PROCESS CONTROL PLATFORM

Procontrol P14

Flash memory on 83SR50, 83SR51 & 81EU50 is not writable

Product bulletin

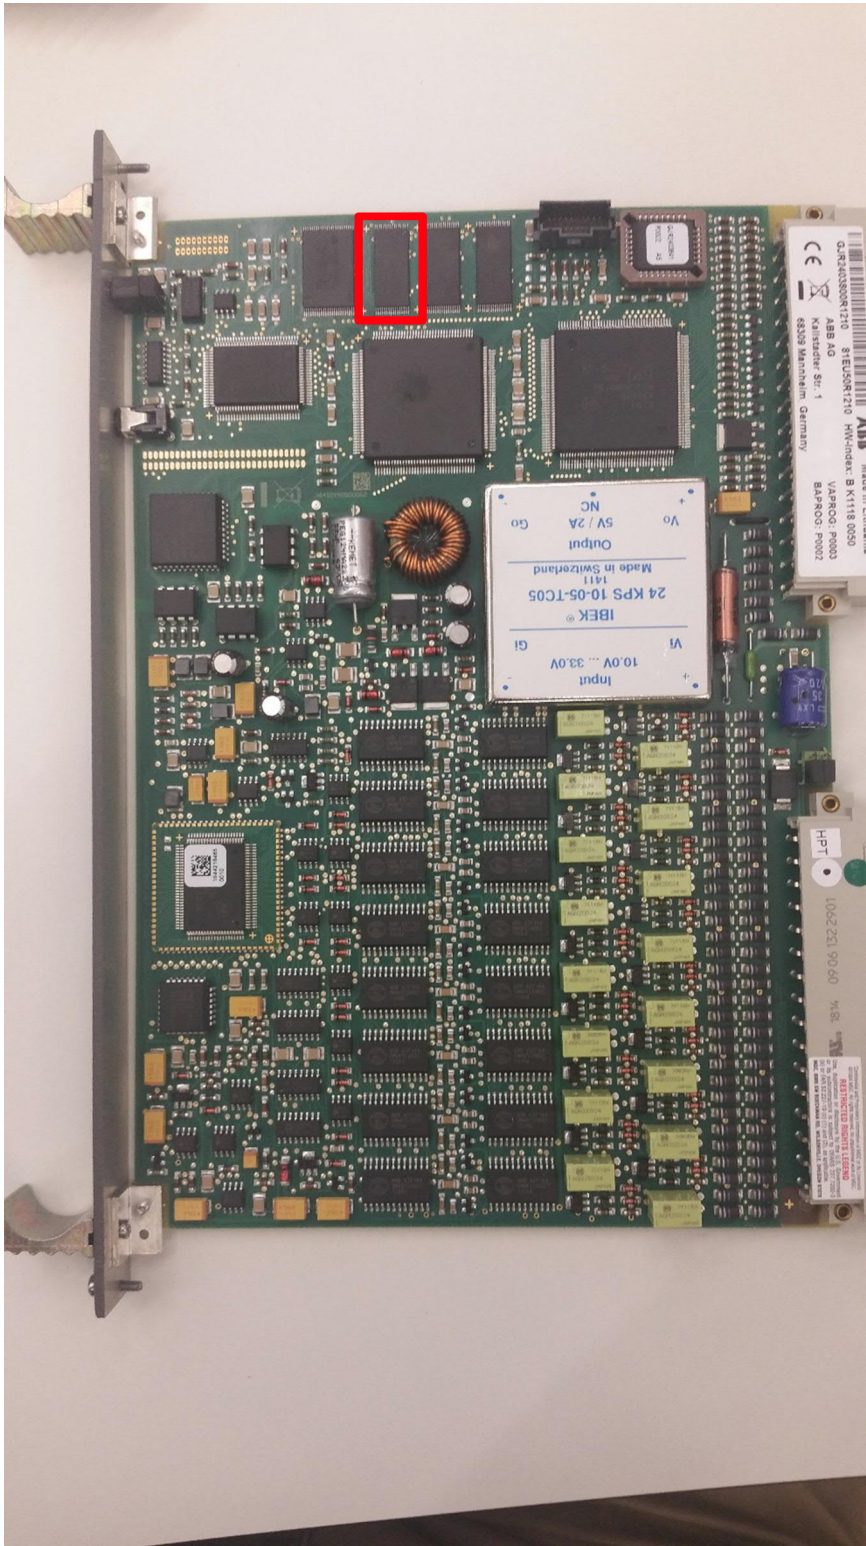
1. Identify the production date of the modules. This can be done by checking the label on the package or the connector. Or it can be done using GAF/OVE functionality of PDDS.

The label is e.g. printed with the following information:

Ident number	Module Designation	HW-Index	Date code + Serial number
GJR2403800R1210	81EU50R1210	HW-Index: B	K1118 0050

The date code is structured as following: YMMY. (Y=Year, M=Month)

For example, for K1118 0050 production date would be 11/18 (November 2018).

83SR50R1210

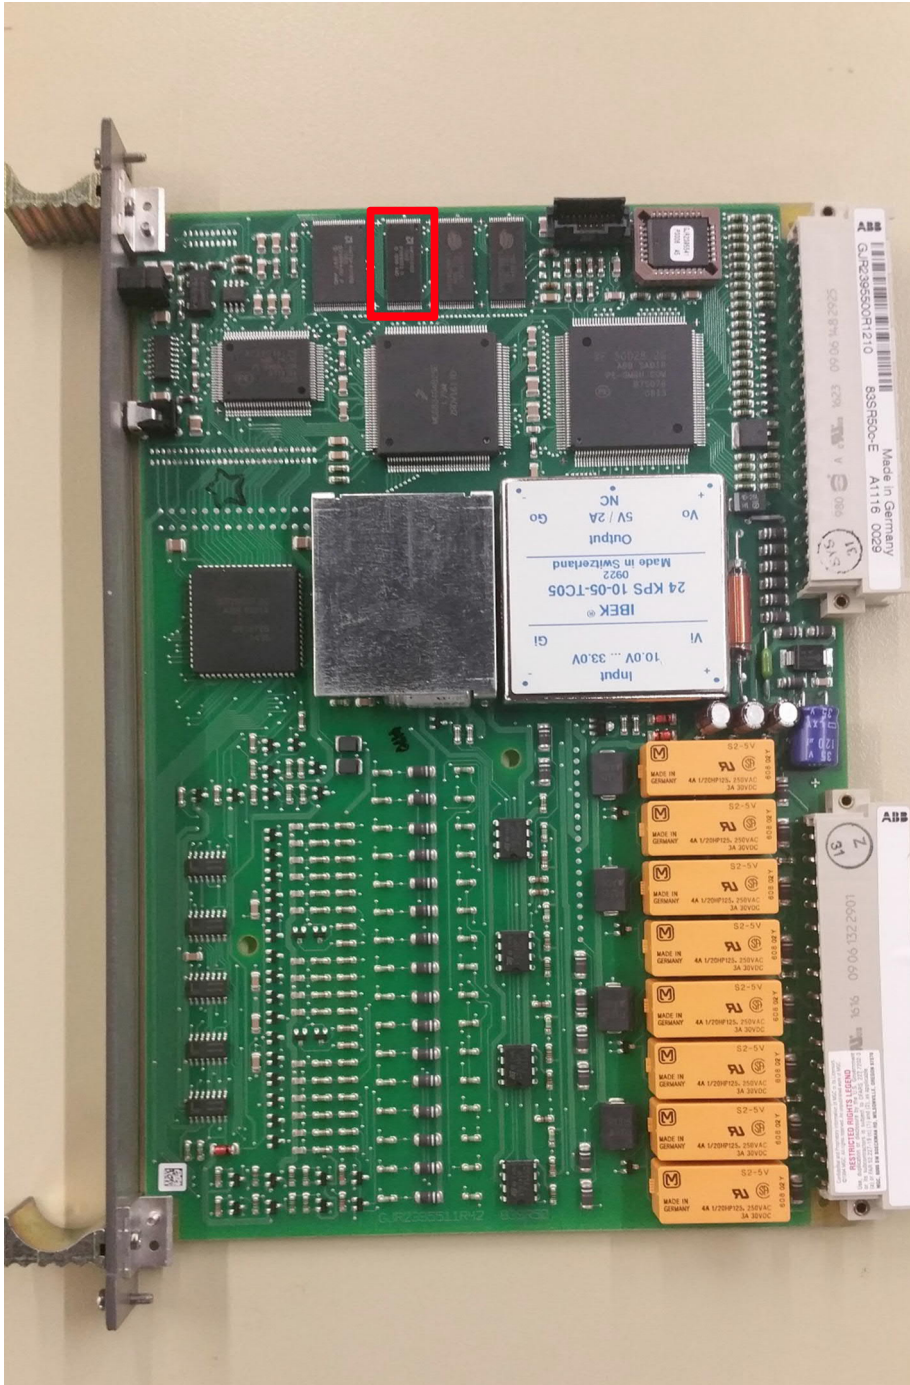
Component is located on the top left of the module as shown in the following picture.

Component is located on the top left of the module as shown in the following picture.

Label of faultless Flash (Manufacturer AMD):

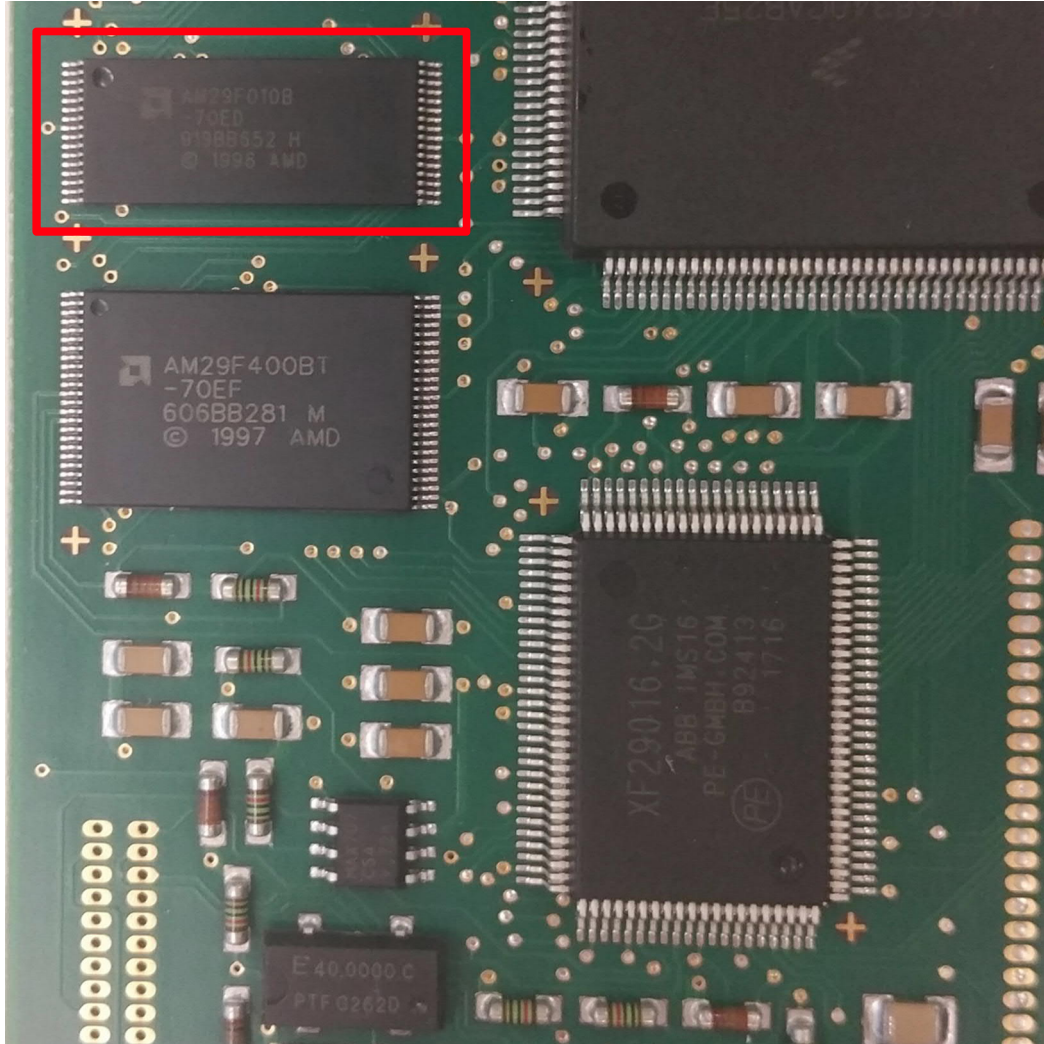
AM29F010B

-70ED

Label of faulty Flash (Manufacturer: Macronix):

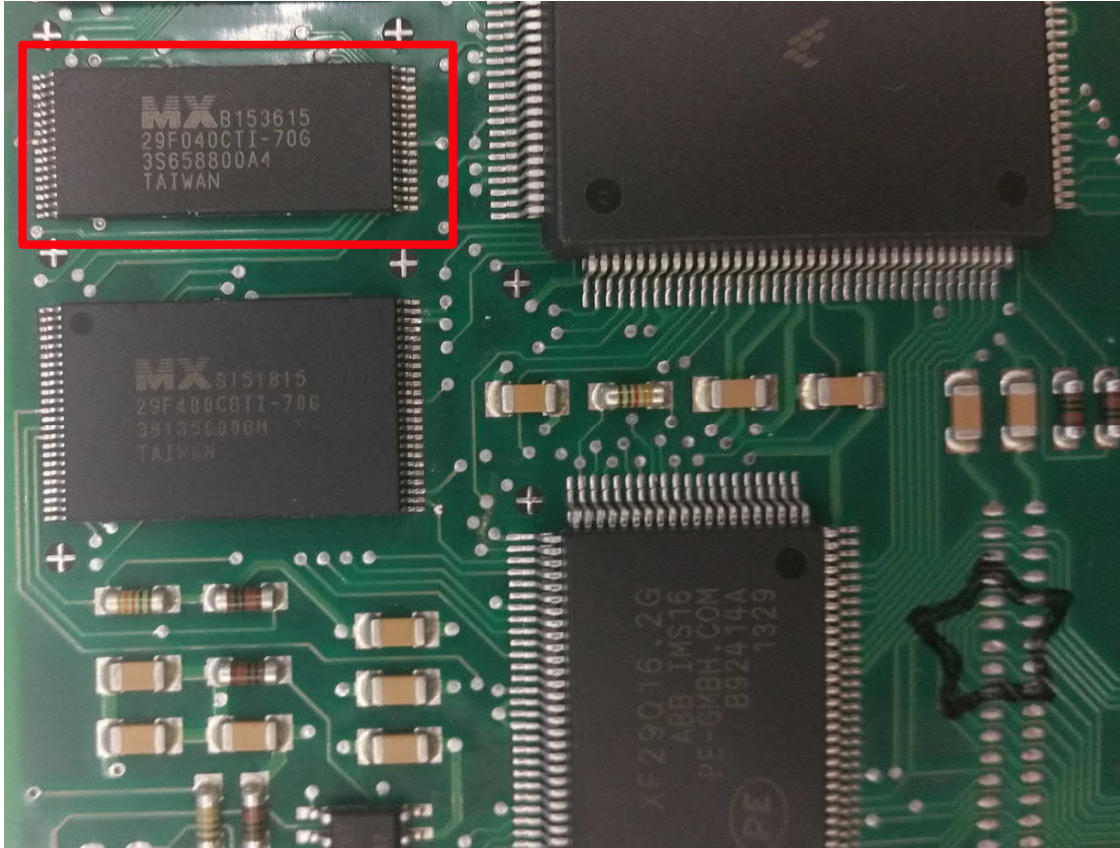
Due to the obsolescence of a Flash PROM (Manufacturer: AMD) on the three modules 81EU50R1210, 83SR50R1210 and 83SR51R1210 the replacement component (Manufacturer: Macronix) was implemented in October 2018.

Copying from RAM to Flash does not or only partly take place. If you try to read back the application program with PDDS it is queried from the Flash. Since there are no data or incorrect data, the error message appears "Disable, list code not found".

MXxxxxxxx
29F040CTI-70G
xxxxxxxxxxx
TAIWAN

- CAUTION: No changes should be made to the application. The module is running the application program stored in the RAM if no further actions are done via PDDS, KISS or EDS.

Also, the module should not be pulled and plugged. After power off the application program in the RAM is lost.

- Either spare modules can be delivered to the project or the modules can be send directly back to Feeder Factory via normal repair process.
